SNPP BRIEFING NOTE

APPLICATION NUMBER:	DA2024/1362
PROPERTY ADDRESS:	40 Myoora Road TERREY HILLS NSW 2084
PROPOSAL:	Demolition works and construction of mixed-use hospitality venue with supporting car parking, servicing and landscaping works
APPLICATION ACCEPTED:	18 October 2024
APPLICANT:	The Trustee for Gardoxi Unit Trust
OWNER:	Gardoxi Pty Ltd
COST OF WORKS:	\$33,046,200.00
NOTIFICATION PERIOD:	25 October 2024 - 18 November 2024
ADVERTISED:	25 October 2024
NO. OF SUBMISSIONS:	43 unique (received from the same property) submissions (22 in support and 21 in objection)
DETERMINATING AUTHORITY:	Sydney North Planning Panel
REASON FOR REFERRAL:	Cost of work exceeds \$30 million

Figure 4 Plan showing the overflow car park areas, highlighted in bright green

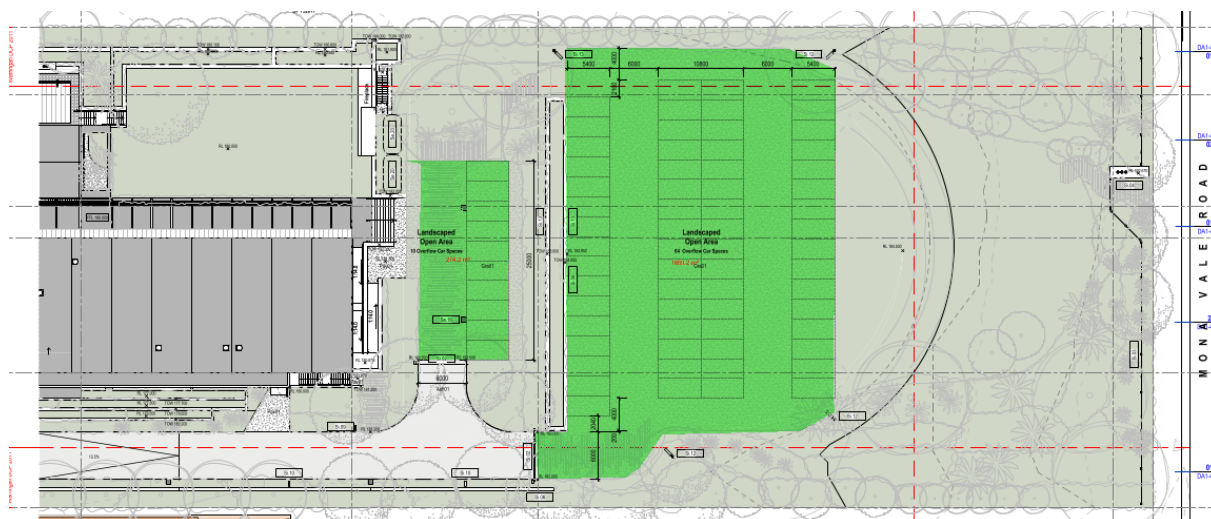
Two areas of LOS, comprising 1,954.2m² in area, are proposed to function as overflow car parking areas which will have a further impact on the quantity and quality of the LOS. It is noted that Council’s Landscape Officer and DSAP have raised issue with the potential impact of this overflow carparking space on the landscape quality of the area.

Figure 5 Site plan, showing car parking within the front 20m setback as highlighted in red and basement carparking, roof canopy and stage within the 7.5m side setback highlighted in green

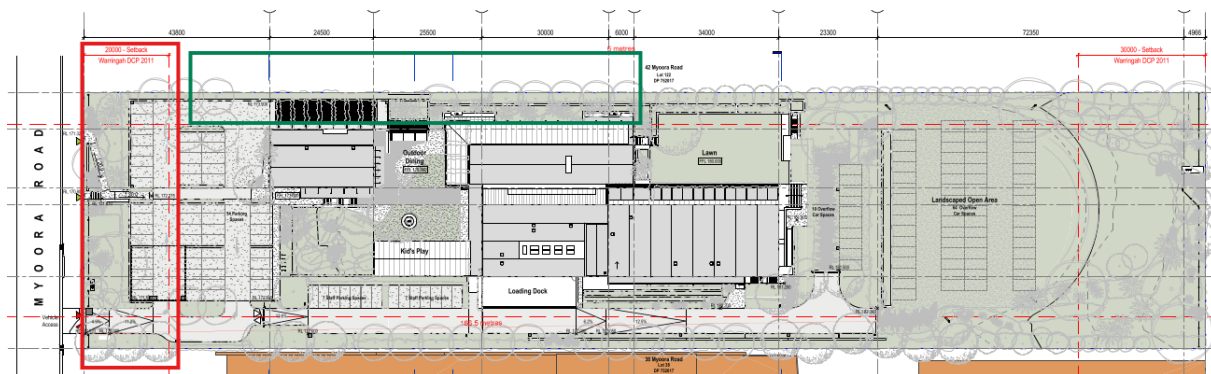
Clause B5 of the WDCP requires a *7.5m side setback*. The following building elements breach the 7.5m side setback on the northern boundary:

- Car parking spaces and the entrance to basement car park
- The roofed structure above the entry to the basement car park
- Part of stage and fireplace x 2 associated with outdoor dining

It is noted that 17 car parking spaces are proposed within the 20m front setback, refer to plan below. In addition, the landscape plan shows a permeable paving area directly in the frontage which is not supported by Council's Landscape Officer.
